[Docket No. NHTSA-2010-0162]

#### Rear Visibility; Federal Motor Vehicle Safety Standard, Rearview Mirrors; Federal Motor Vehicle Safety Standard, Low-Speed Vehicles; Phase-in Reporting Requirements

**ACTION:** Notice of proposed rulemaking; corrections.

In FR Doc. 2010-30353, beginning on page 76186 in the **Federal Register** of Tuesday, December 7, 2010, the following corrections are made:

Figure 6. Countermeasure Performance Test Area Illustration and Required Test Object Locations

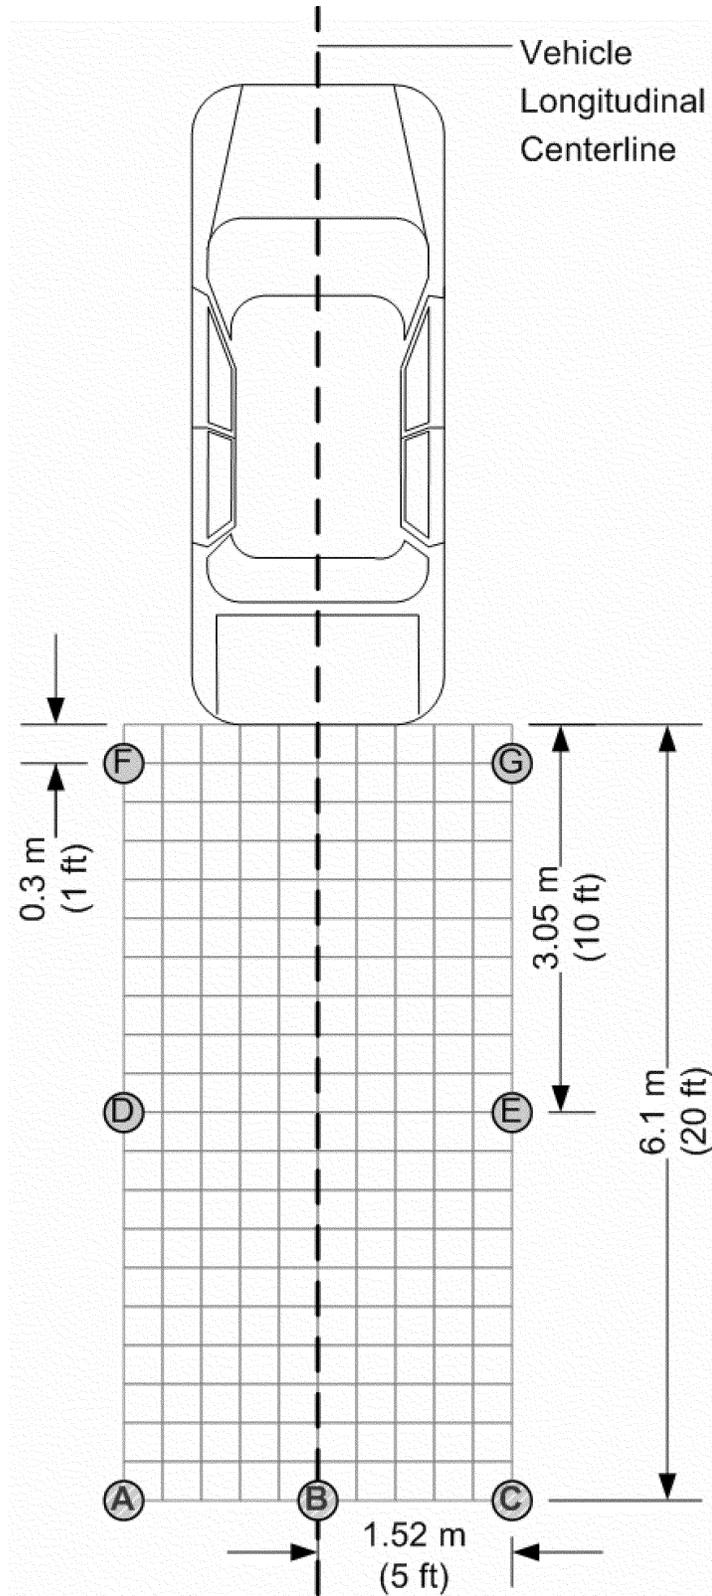
2. On page 76234, figure 6 is corrected to read as follows:

FIGURE 5: TEST CYLINDER LOCATIONS (Units in meters)

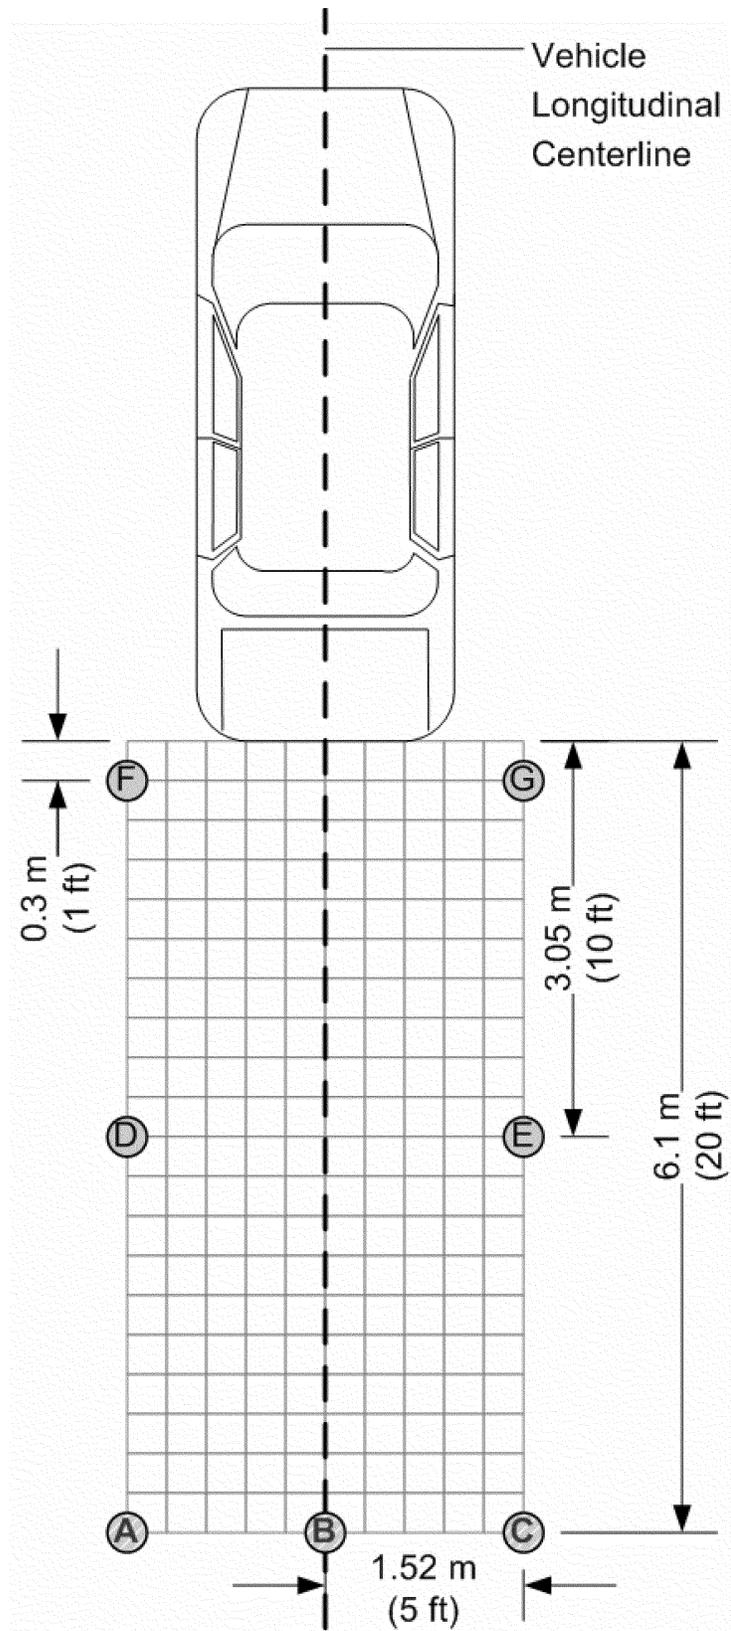
24. On page 76248, Figure 5 is corrected to read as follows:
